SERVICE INSTRUCTION

RUNNING MODIFICATIONS ON

ROTAX® ENGINE TYPE 912/914 (SERIES)

SI-912-020 R4

new Version

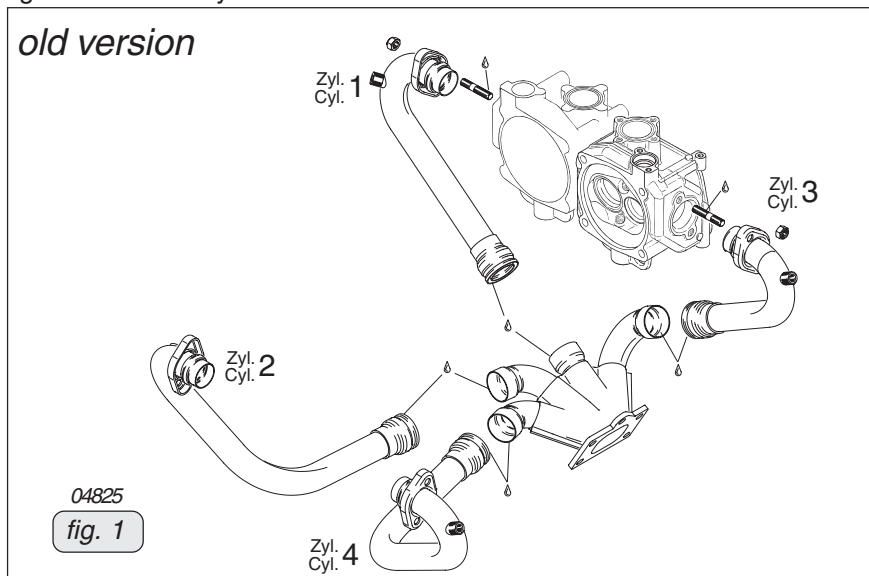
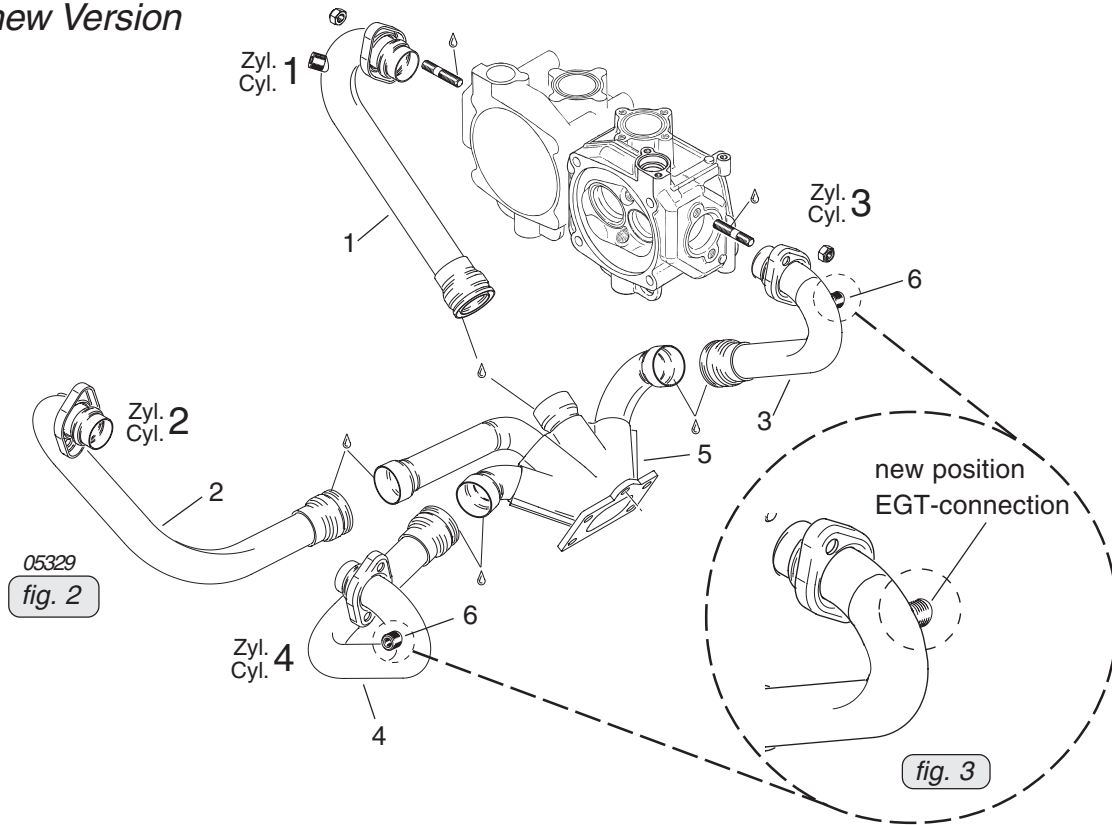
Owing to continuous further development, the exhaust bends were slightly re-worked. The couplings were optimized for their position.

- Position of the EGT connections (6) to the exhaust bends for cylinders 3 and 4 were routed such that installation of the new drip trays is possible.

◆ NOTE: If replacement of any single old part number is necessary, you must replace it with the same old part number. If the old part number is not available, the **entire** assembly including all 4 pipes and manifold must be replaced with new part numbers. New style pipes and manifold are not interchangeable with old style.

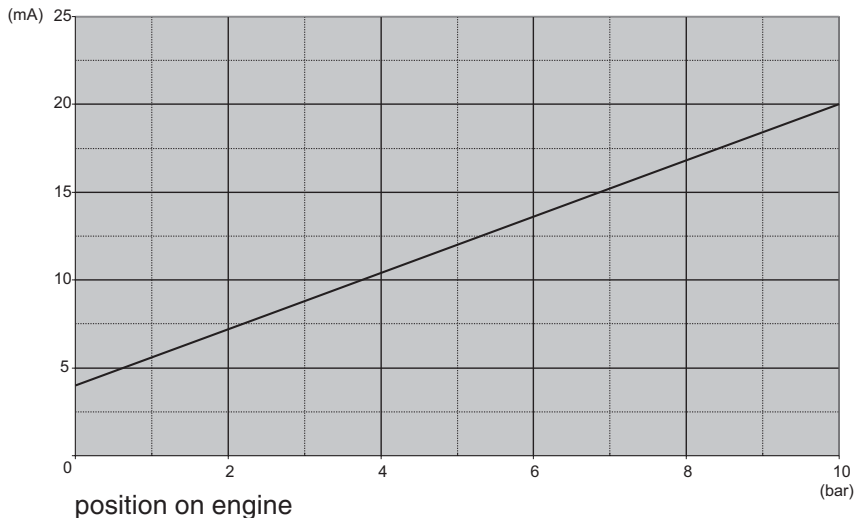
In contrary to the oil pressure sensor offered up to now, which was providing the signal on the basis of a sensor resistance variation, the new oil pressure sensor operates on basis of a current variation. This has to be taken into account for the selection of the appropriate cockpit instrument.

■ **CAUTION:** The graph current over pressure has been determined, and is effective at the following conditions only (see fig. 1).

fig. 2

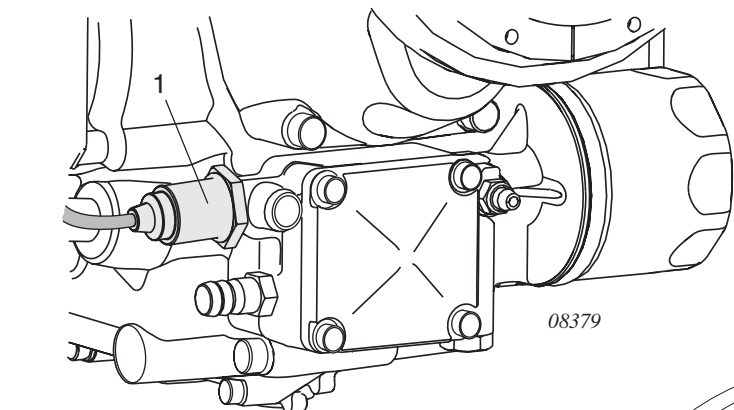
The sensor cable is approx. 3 m long and has 3 leads. The **Black** lead is not to be connected and has no function. The **Red** lead from the sensor has to be connected to the positive bus via a fuse or circuit breaker. The **White** lead (output signal) has to be connected directly to the instrument. See also the relevant instructions of the instrument supplier/aircraft manufacturer for correct connection and wiring.

◆ **NOTE:** The sensor cable can be modified in its length according to the installation situation, e.g. shortened or extended. For extension an appropriate, commercially available cable can be used. A resistance cable or similar is not necessary.

fig. 3

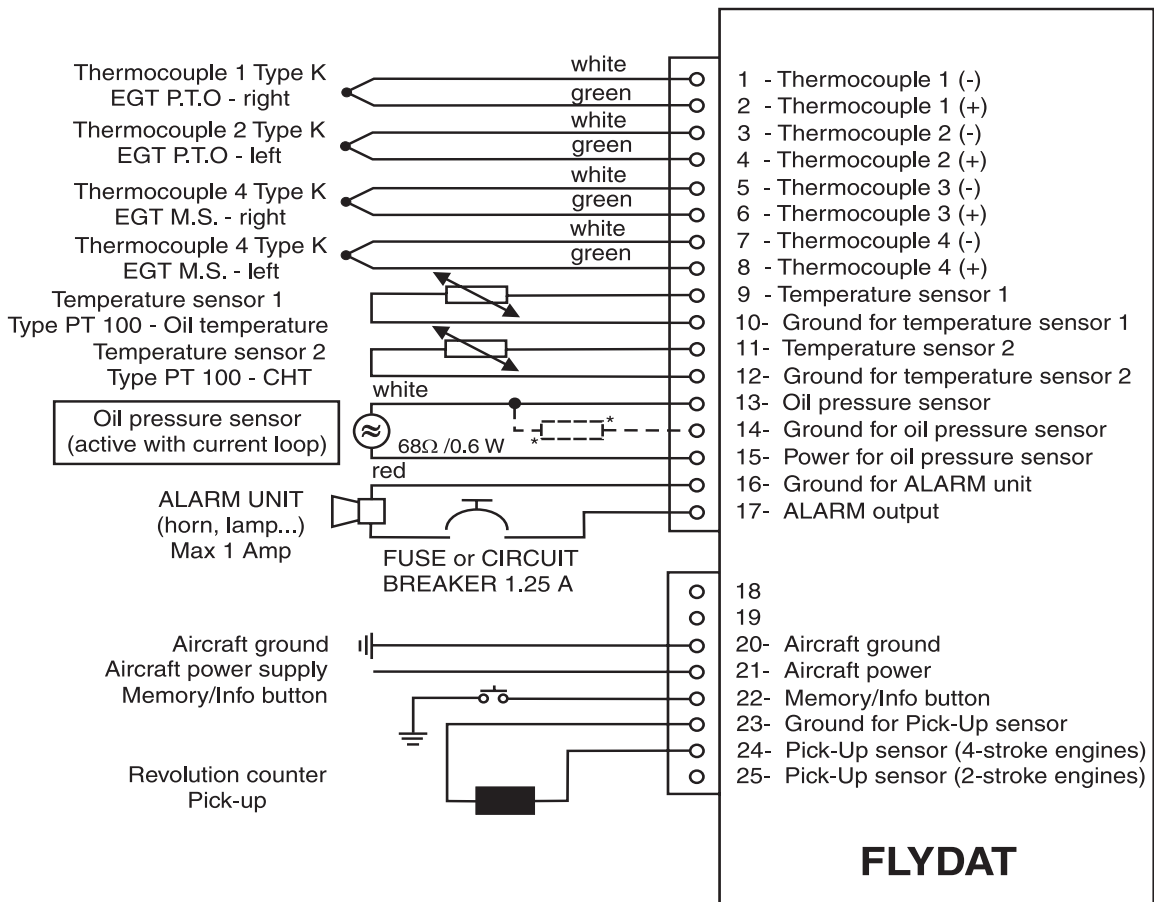
* resistor is part of the retrofit kit for Flydat part no. 886857. See also 1.3.2.
